Rezoning Application: PD 24-0932
Zoning Hearing Master Date: October 28, 2024
BOCC Land Use Meeting Date: December 10, 2024

APPLICATION NUMBER: PD 24-0932

2.4 Proposed Site Plan (partial provided below for size and orientation purposes. See Section 8.0 for full site plan)

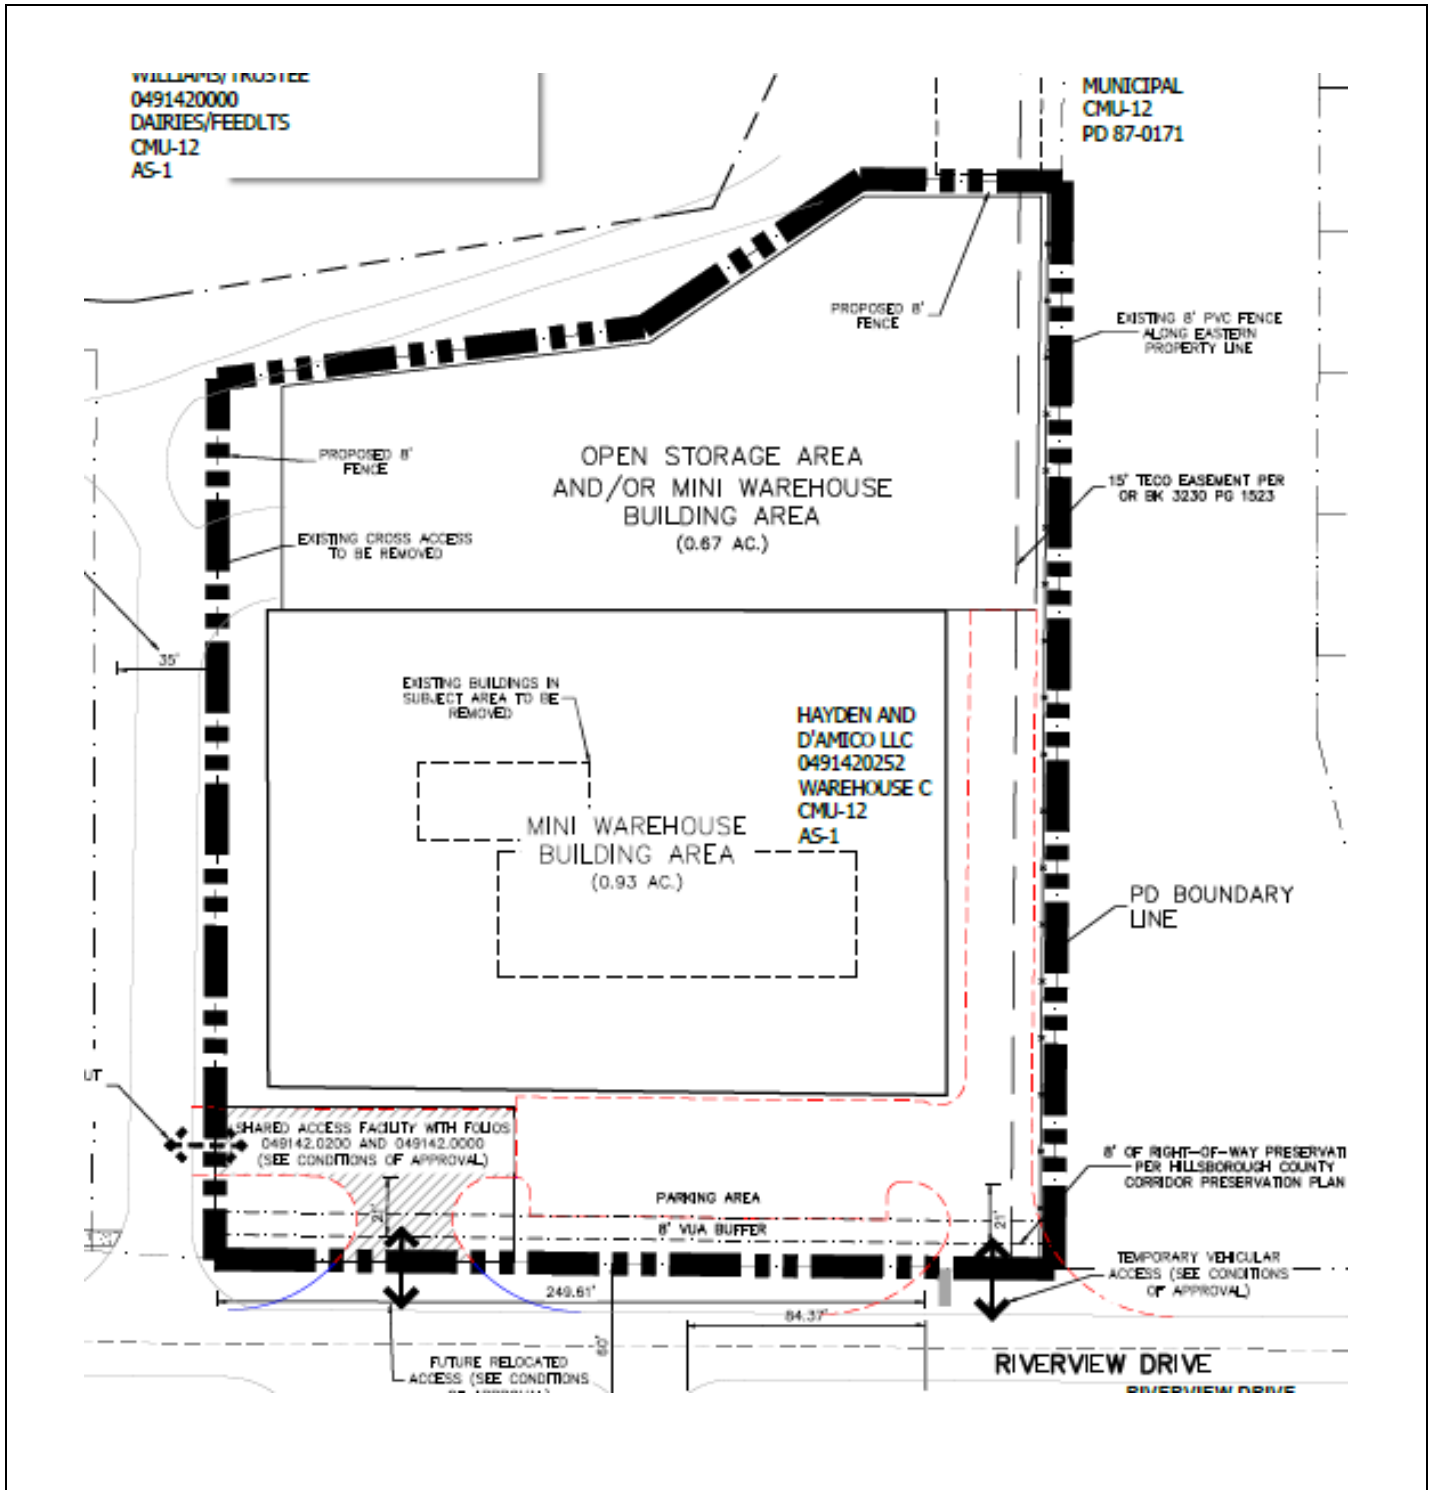
The site plan does not the requirements of LDC Section 6.06.06 Buffering and Screening. The applicant is required to provide a 30-foot-wide buffer with Type "C" screening along the eastern and northern boundary of the adjacent to the residential and agricultural zoning because Open Storage is proposed in the rear of the subject site and is considered a Group 6 use. However, the applicant proposes a variation to allow an increase in fence height along the side and rear perimeters to allow an 8-foot fence which will more effectively screen the outdoor storage from the adjacent properties and public right-of-way than a 6-foot fence.

- Correct the Mini-warehouse acreage under “Proposed Use” from 0.93 ac. to 2.34 ac. for Mini-warehouse.
- Clearly delineate with “dotted lines” area where Open Storage shall be permitted.
- Shift the internal driveway westward off the 15’ TECO easement area.
- Remove 8’ fence shown on site plan along the western property boundary.

1. The project shall be developed in general conformance with the August 28, 2024, site plan and be limited to the following uses.
 - Open Storage is allowed as specified on the site plan in the 0.67-acre area located in the northern portion of the subject property.

- a. A zero-foot buffer with an 8-foot opaque fence shall be allowed along the northern and eastern property boundary for both Open Storage and Mini-warehouse uses.
